**ADDENDUM #1
Public Works
95th Resiliency and Reconstruction
BID-009-23**

January 17, 2024

Per the discussion and subsequent Q/A above, the following plans and specifications have been amended and added to this addendum. Along with this addendum an, additional Q/A session has been added along with a new bid due date:

95TH STREET RECONSTRUCTION DESIGN,
BOULDER CREEK TO LOOKOUT ROAD
BOULDER COUNTY
SECTIONS 8, 9, 16 & 17, T1N, R69W OF THE 6TH P.M.
BOULDER COUNTY PROJECT RD019-150

Drawing Number G-001

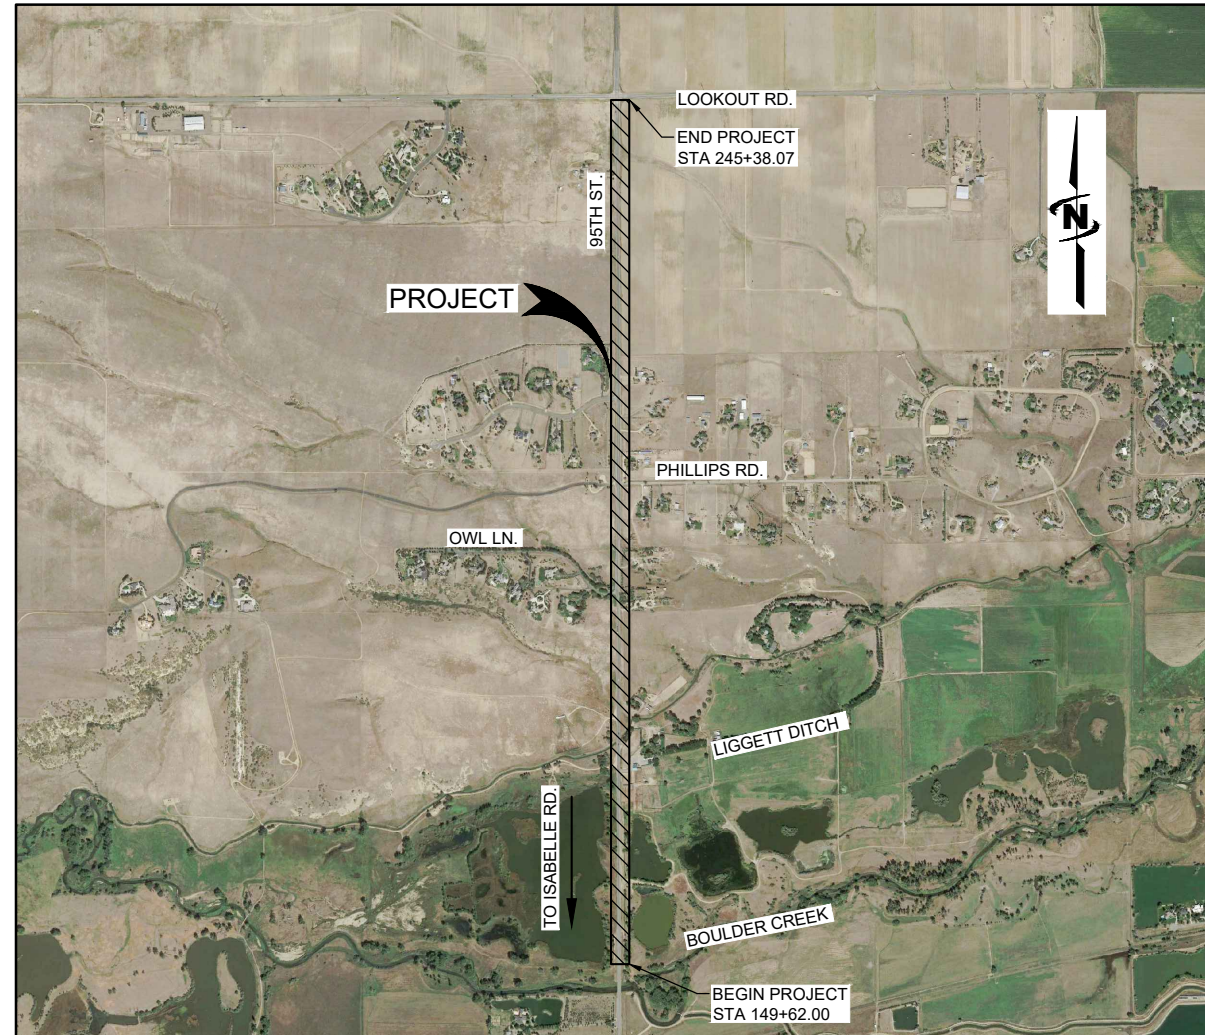
- **Change sheet list table – Traffic Phasing was incorrect, actual drawing name of sheets 80 to 83 is Signing and Striping.**

C ASPHALT BUILD UP SECTION
SCALE: NONE

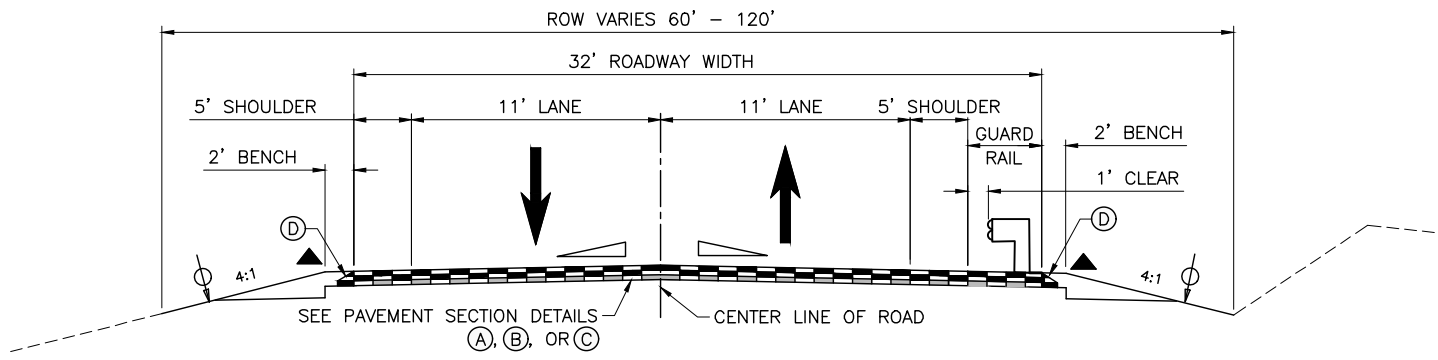
3. Question: According to the roadway section B & C, the design calls for 2" intermediate lift of S Mix and a 1"-4" leveling course with S Mix. With the lift thickness needing to be three times the maximum nominal aggregate size of the mix, 2.25" would be the minimum for S Mix. Will the sections be modified to reflect this?

- Changed pavement Section "C" – Leveling Course shall be 1 ½" – 4" of Grading SX

ANSWER: The typical section has been amended to reflect a constructible lift versus the mix gradation.
